**Addendum #04**

**Victoria Park Community Housing**

**PROJECT NUMBER: 12228**  
**DATE ISSUED: October 11, 2023**

**Construction Tender  
ARCHITECTURAL ADDENDUM  
No. 04**

## SSUR(SILL) - SOLID SURFACE SILL DETAIL

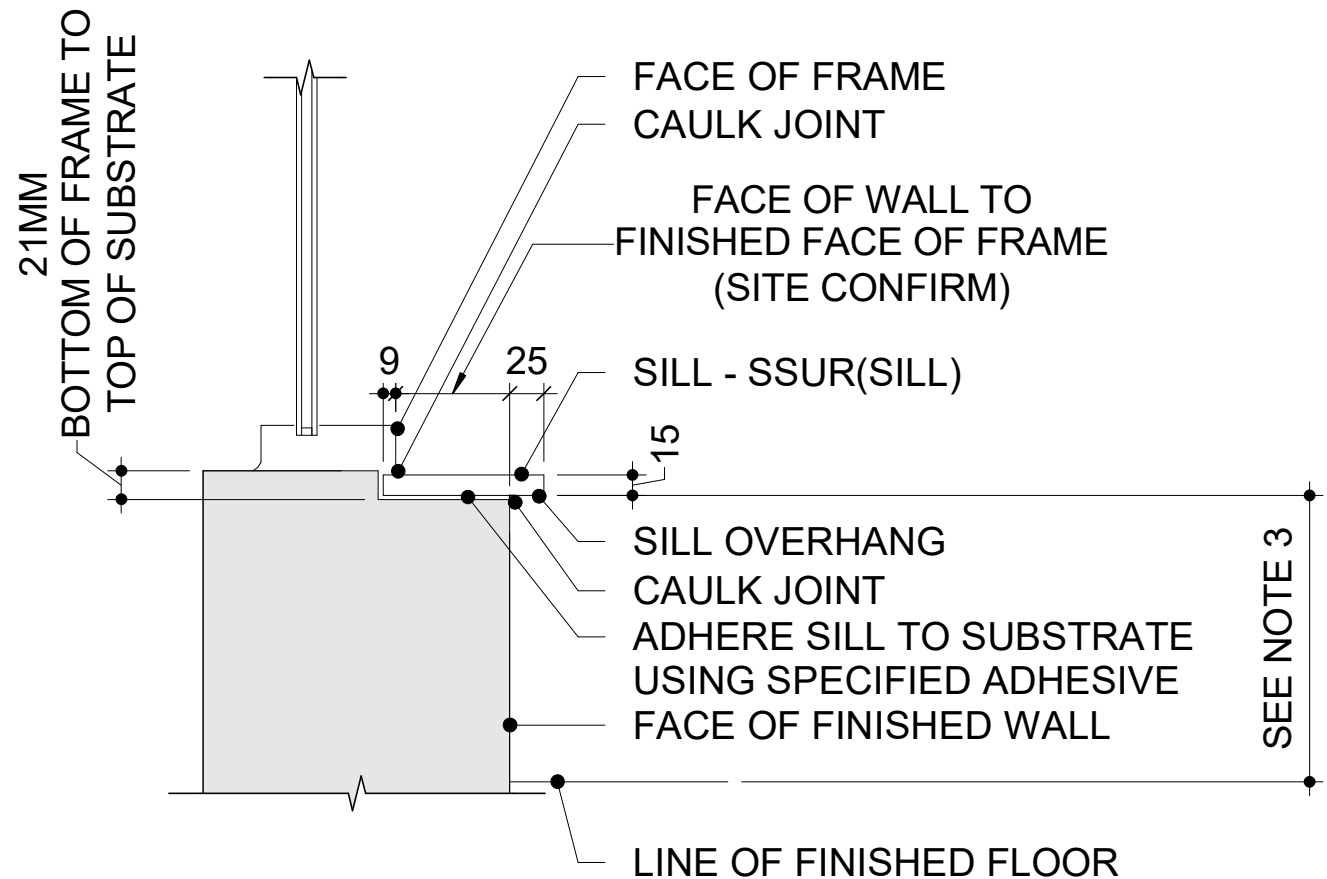
**Response:**  
*Plan dimension to govern.*
- 5 **Question:**  
Please clarify if the solid surface sills at exterior windows indicated in Addendum 3 Q&A #34 is to be terrazzo (ST-01), if not please provide specs required?

.iii Insert attached Detail of Window Sill – Solid Surface to Drawing A A01.07 FLOOR FINISH PLAN.

**Response:**  
*All solid surface sills for all existing and new windows shall be from Caesarstone – 2141 Blizzard*
- 6 **Question:**  
In the recent Addendum #3 – the RCP shows Window Shade Detail WS and WSBO – can you please confirm we are only providing WS and not WSBO?

## SSUR(SILL) - SOLID SURFACE SILL DETAIL

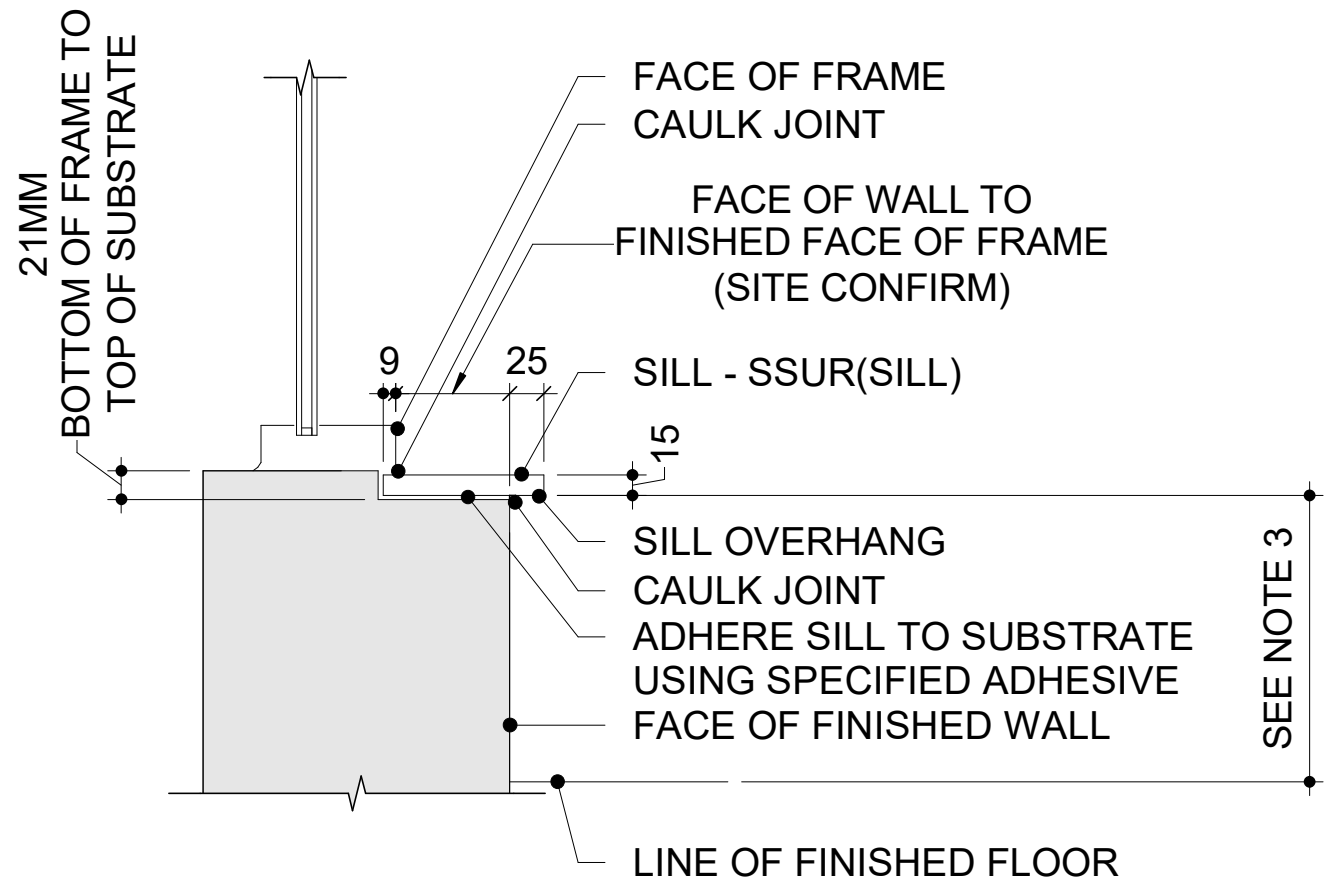
.iii Insert attached Detail of Window Sill – Solid Surface to Drawing A A01.07 FLOOR FINISH PLAN.
